ADDENDUM No. Six (6)

IFB No. 2021-239

CONSTRUCTION, COLLIN COUNTY ADULT DETENTION FACILITY, PHASE 1 ADDITION

ADDENDUM NO. 4

LEVEL 1 WEST -
FLOOR PLAN

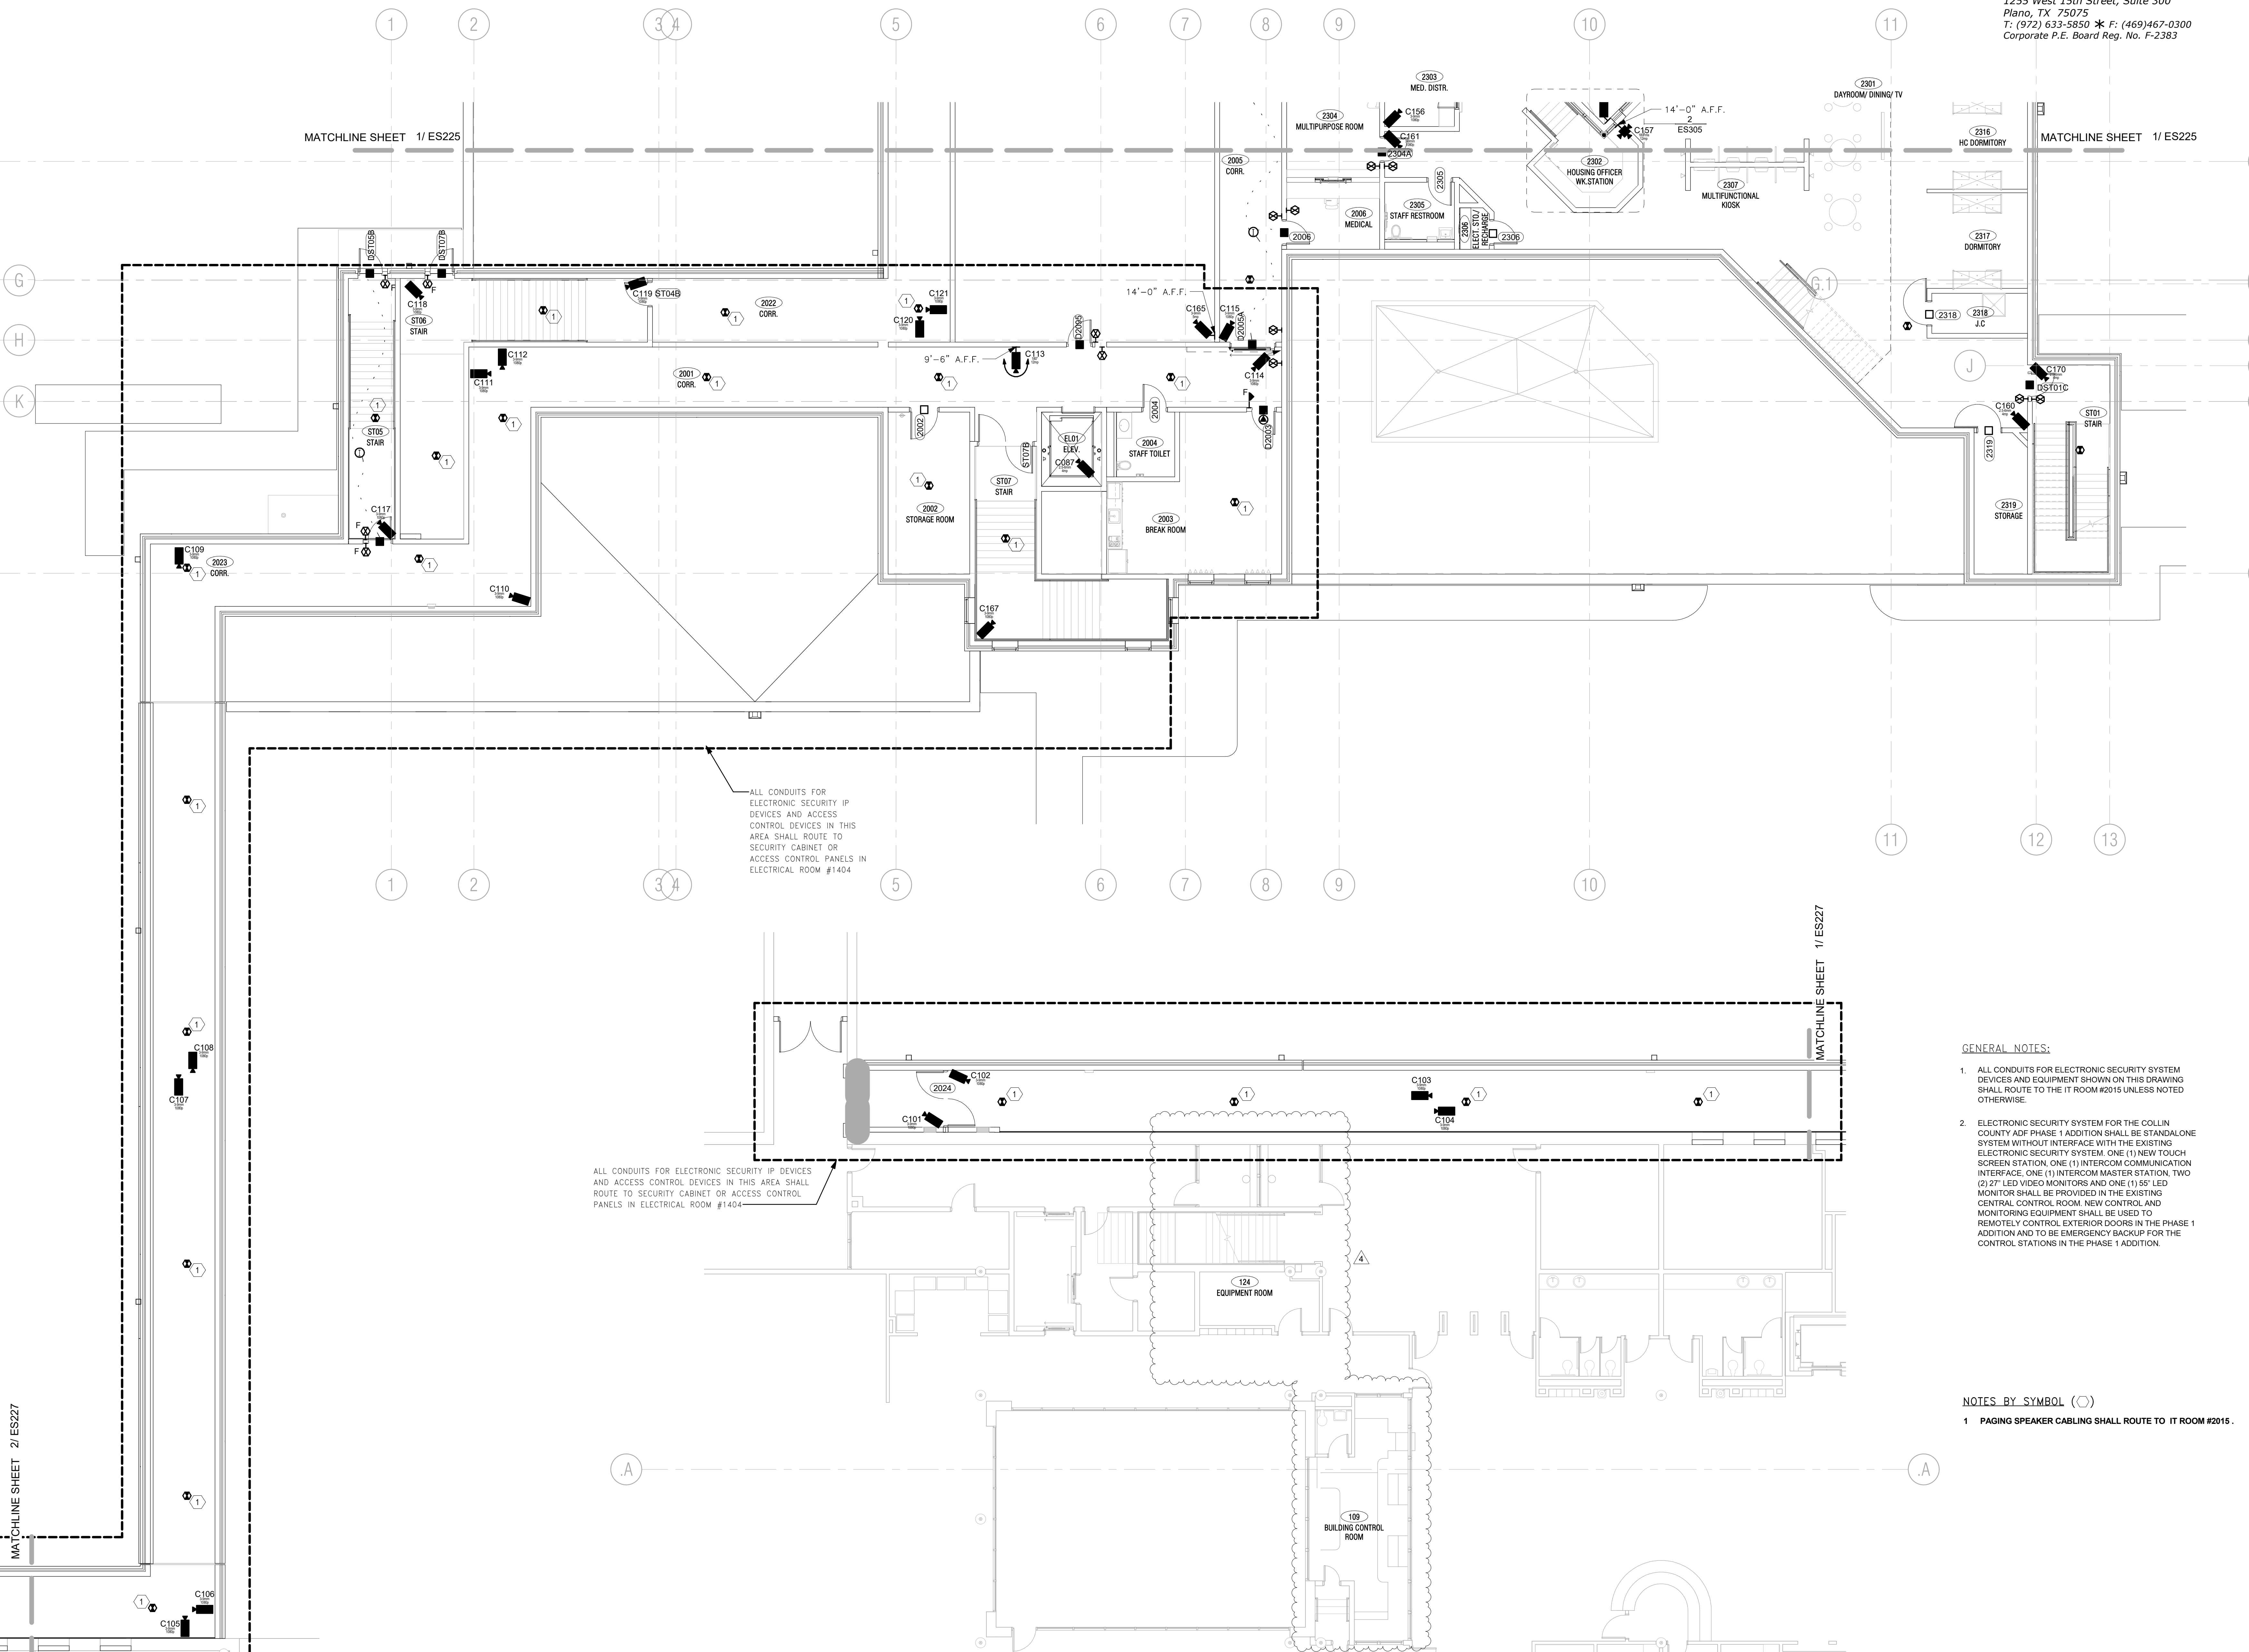
- Item No. 6. Sheet – CVR**
A. Updated to include addendums.
- Item No. 7. Sheet – M100**
A. Added detail 3 and note 2.
- Item No. 8. Sheet – ES227**
A. Modified floor plan view to include location of existing Equipment Room #124 and existing Building Control Room #109.
- Item No. 9. Sheet – ES501**

ACCESS CONTROL SYSTEM DIAGRAM

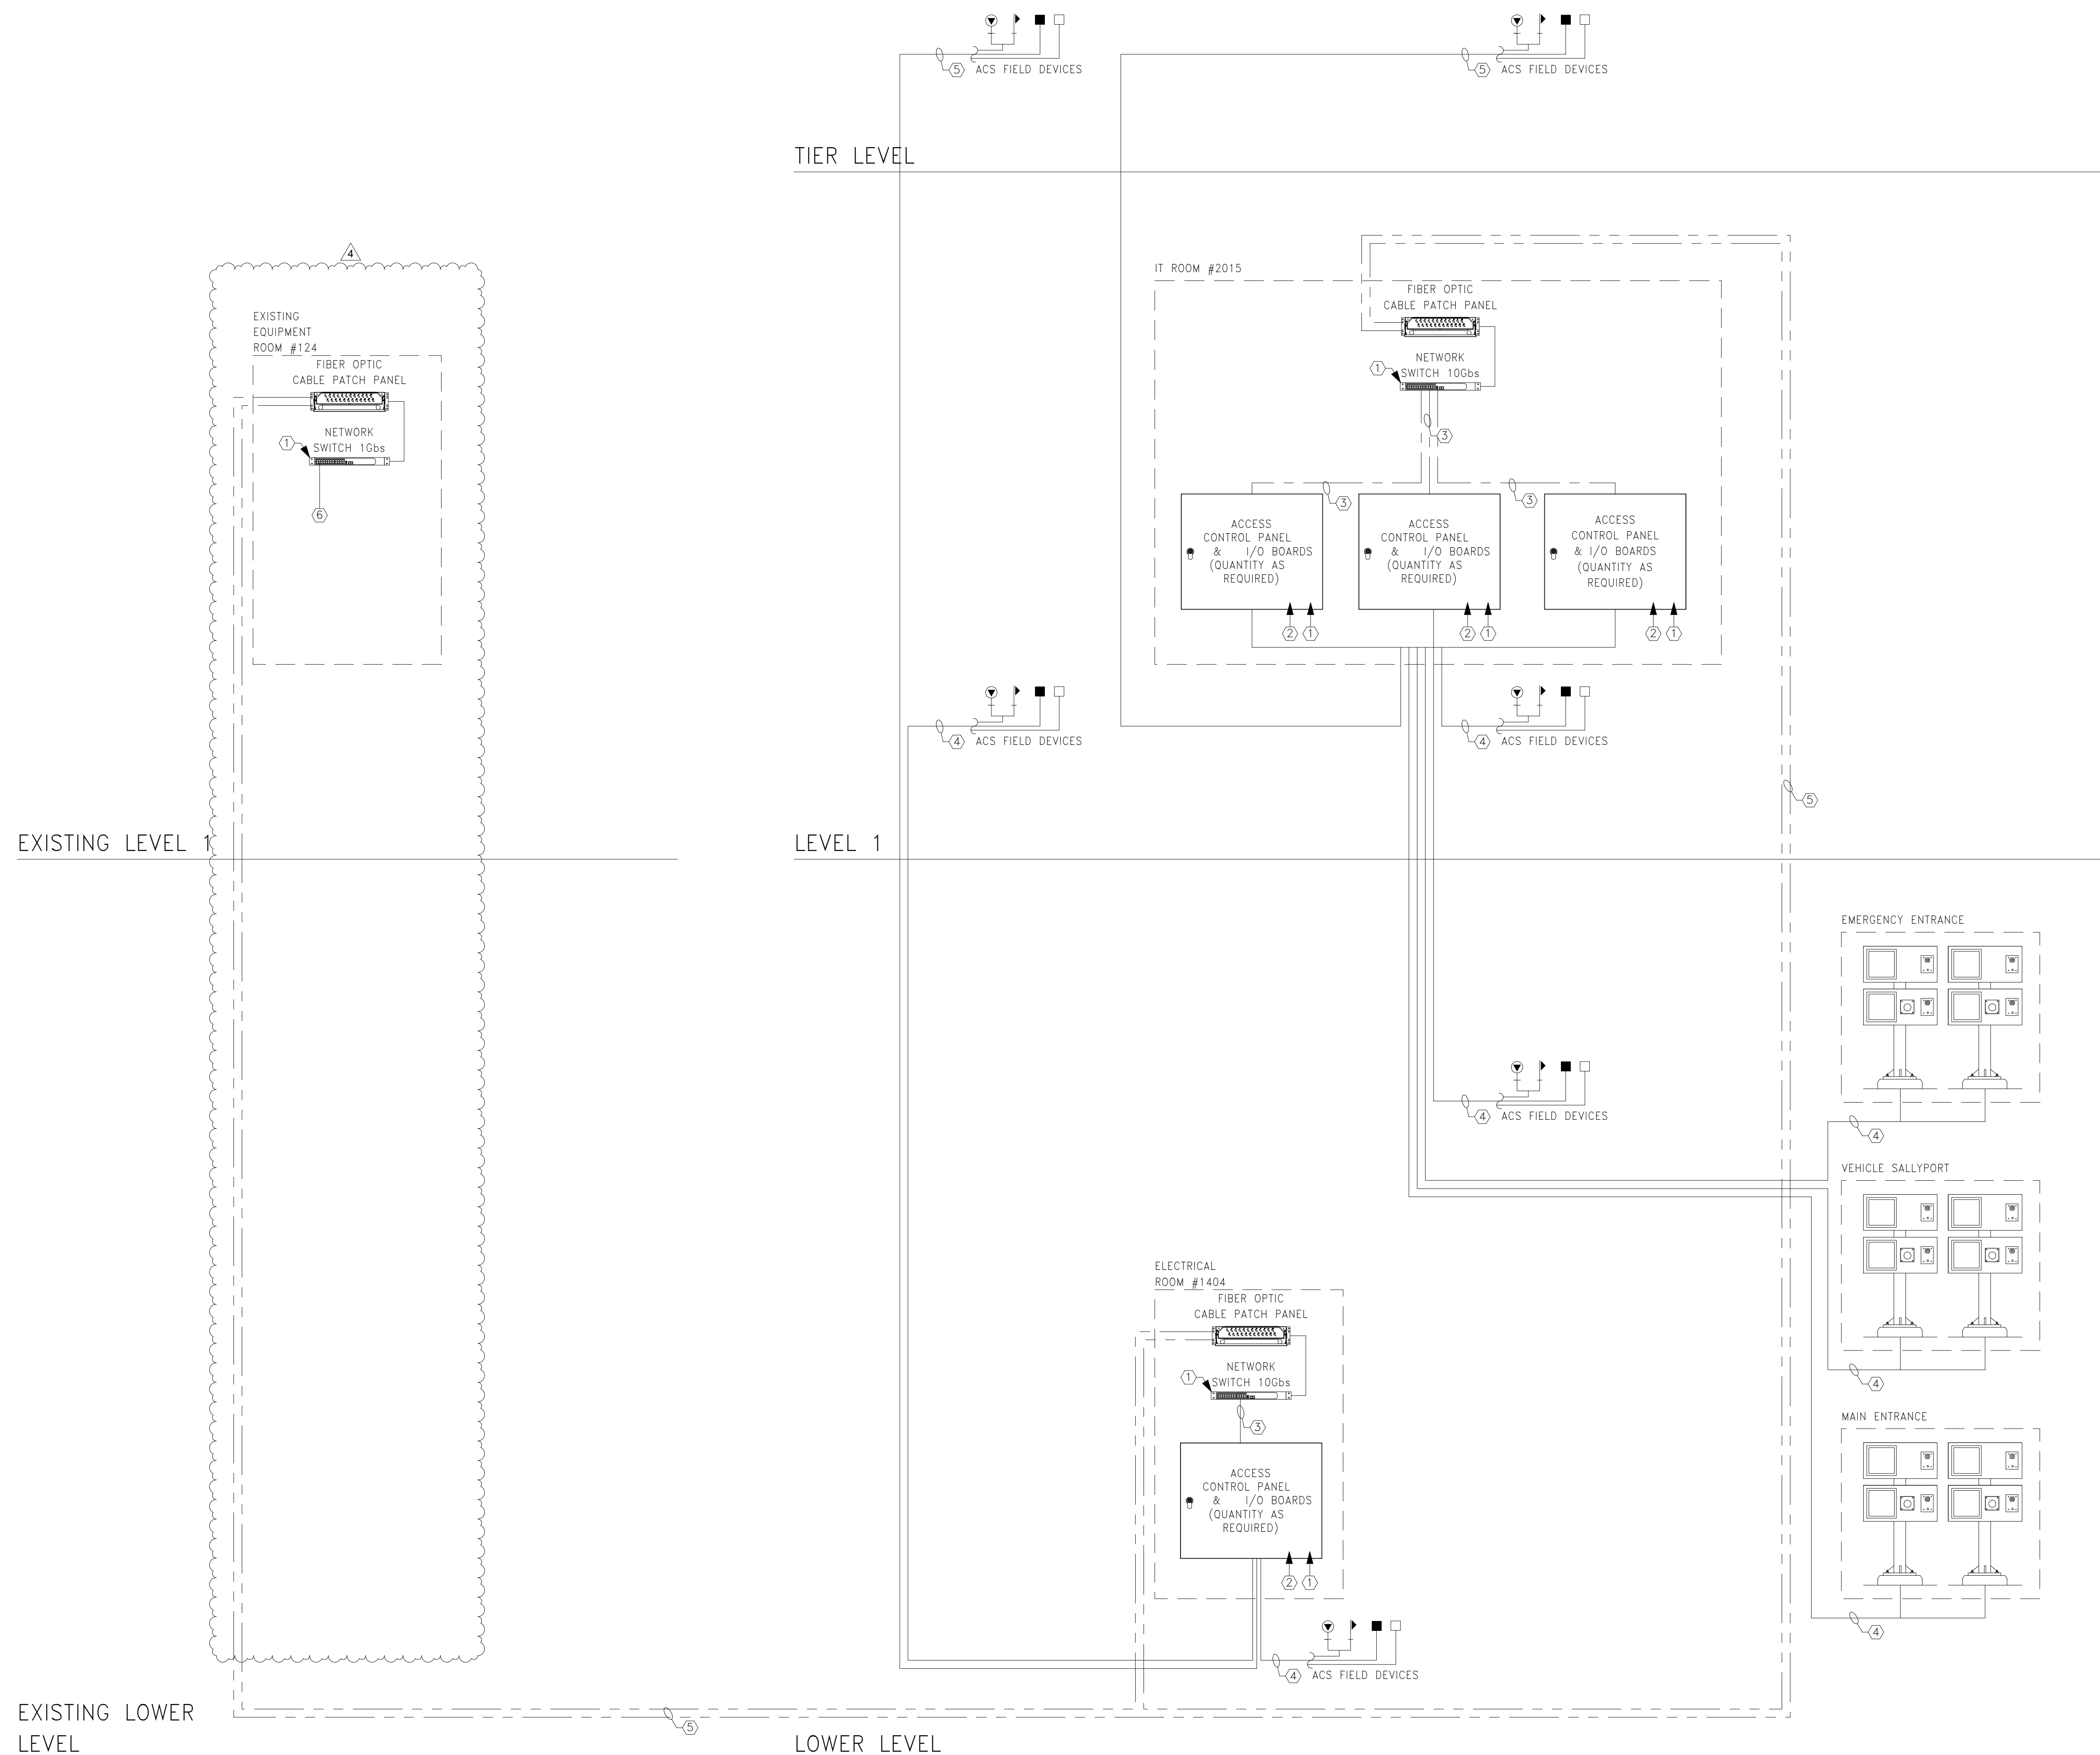
- A. Modified Diagram to correct Existing Equipment Room #129 to #124.
- B. Corrected Diagram by moving Existing Equipment Room #124 to level 1.
- C. Corrected Diagram by moving Existing Building Control Room to level 1.

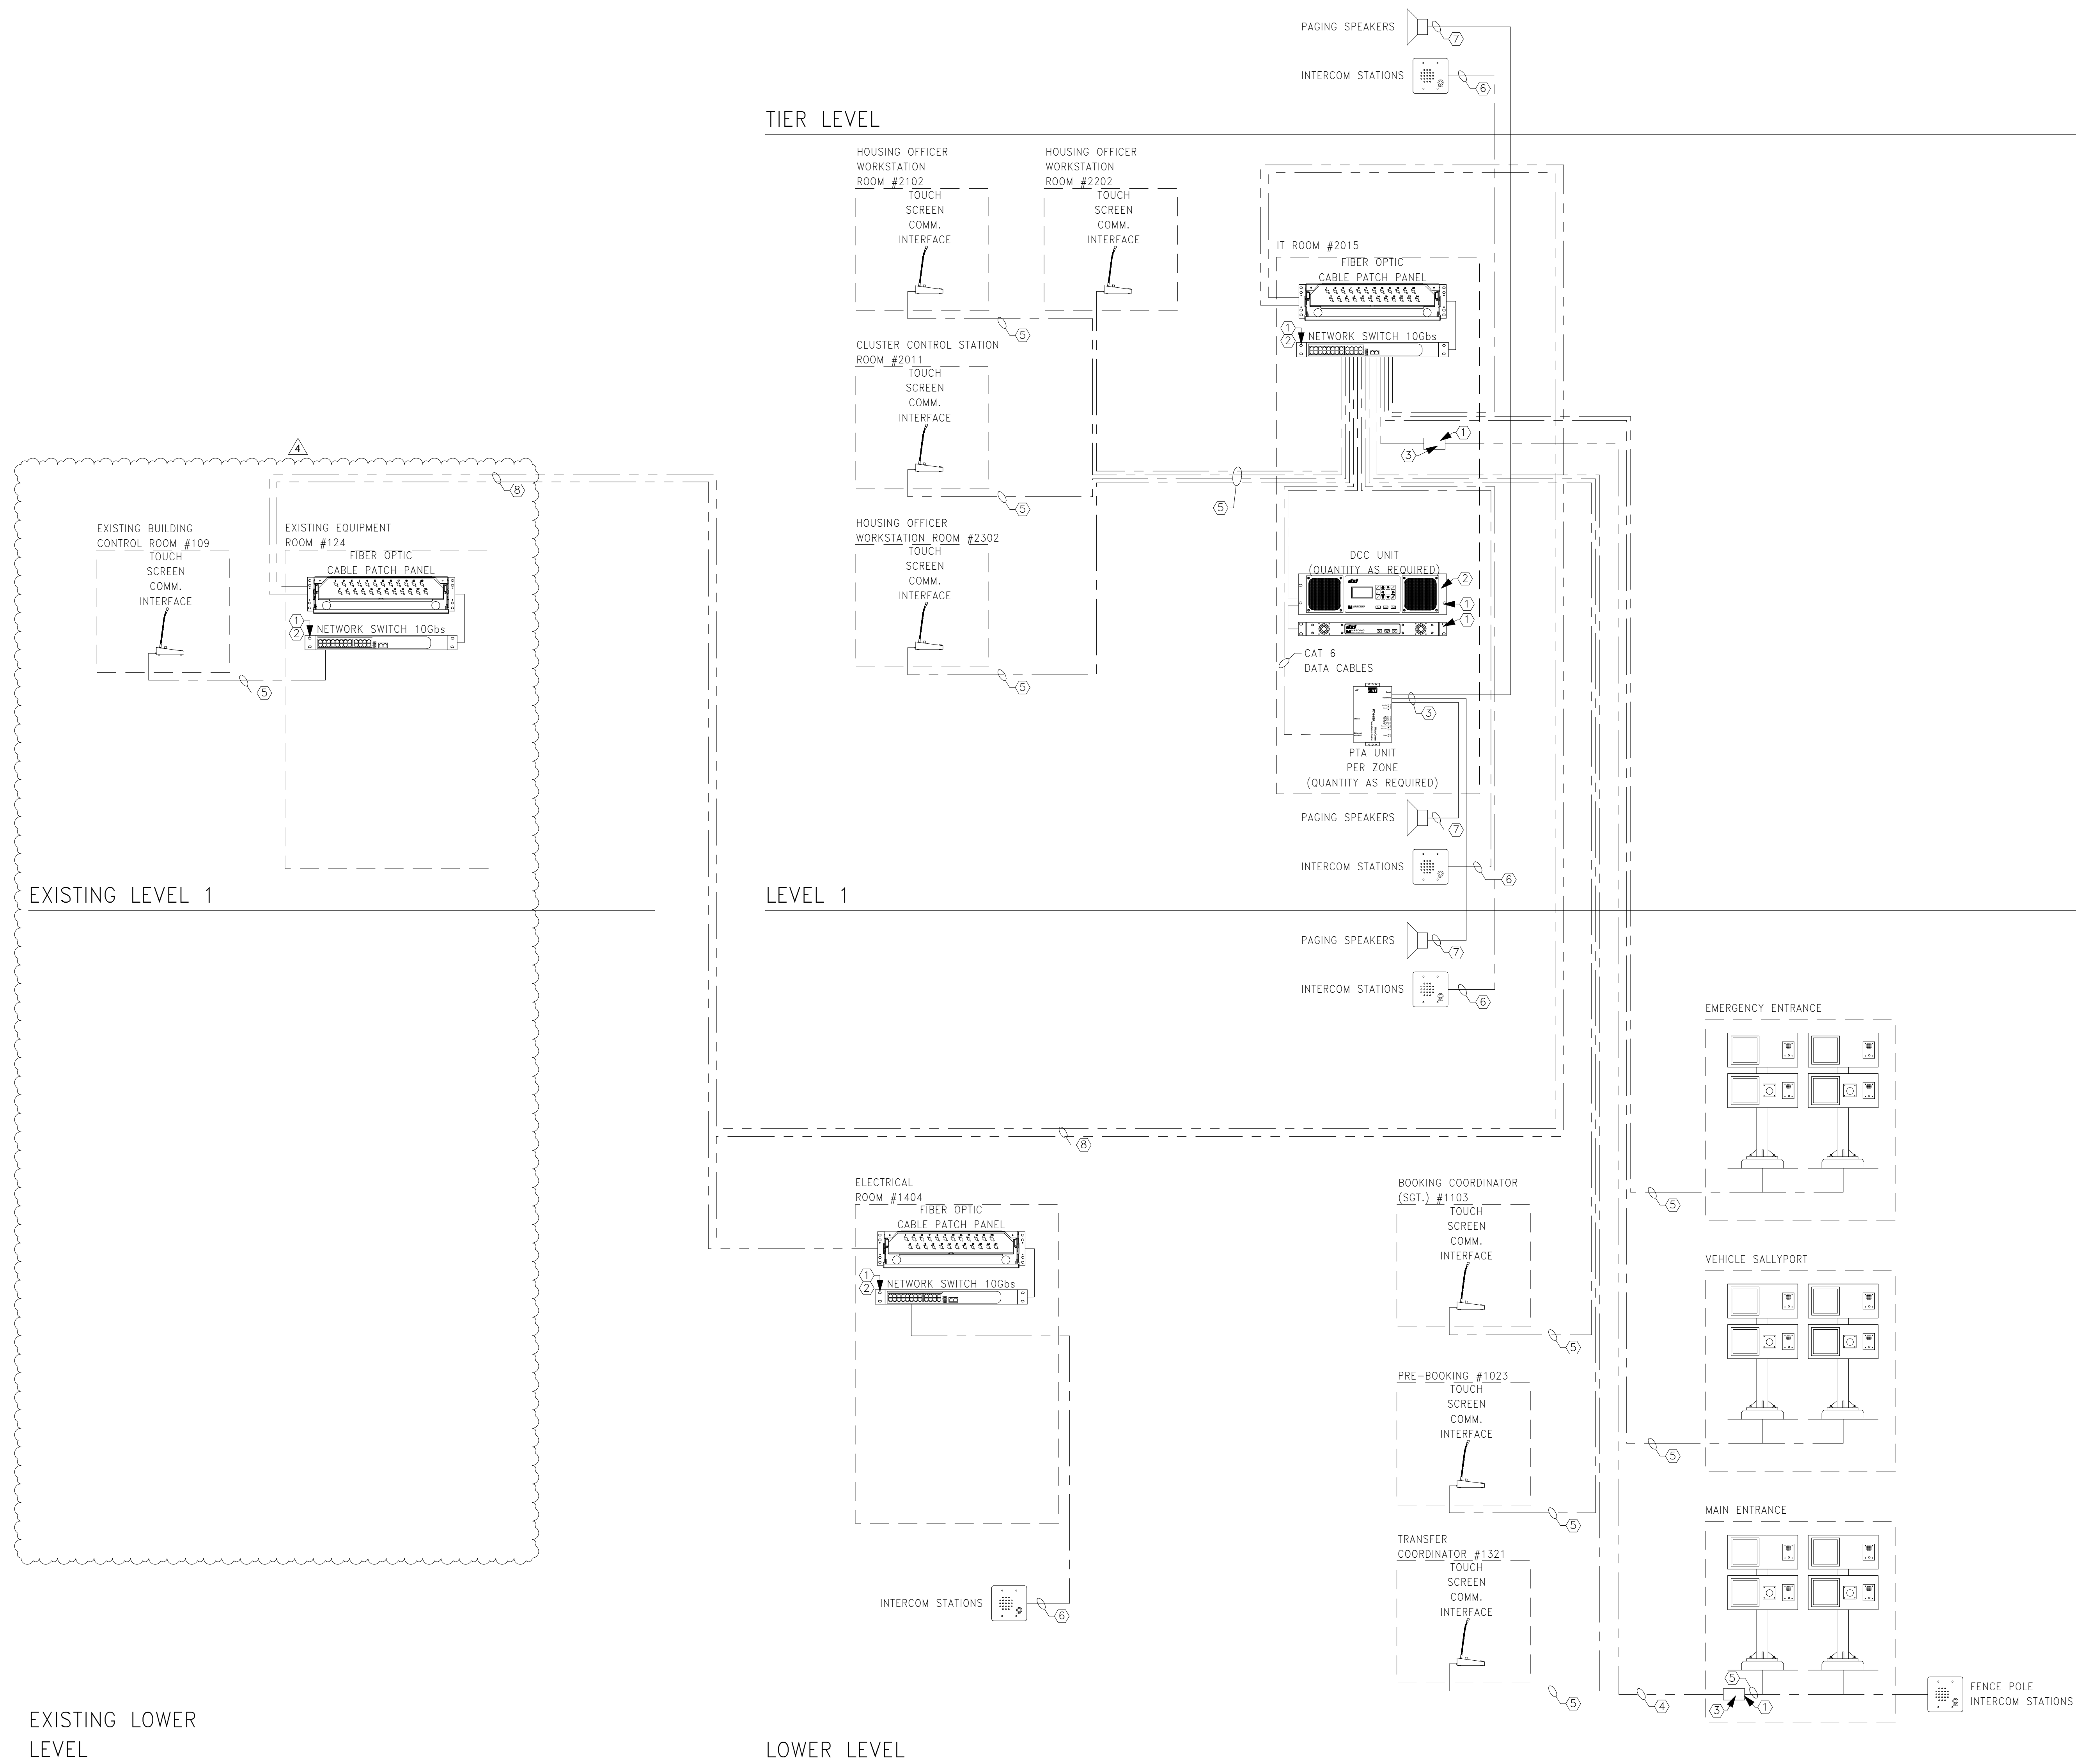
- A. Modified Diagram to correct Existing Equipment Room #129 to #124.
- B. Corrected Diagram by moving Existing Equipment Room #124 to level 1.
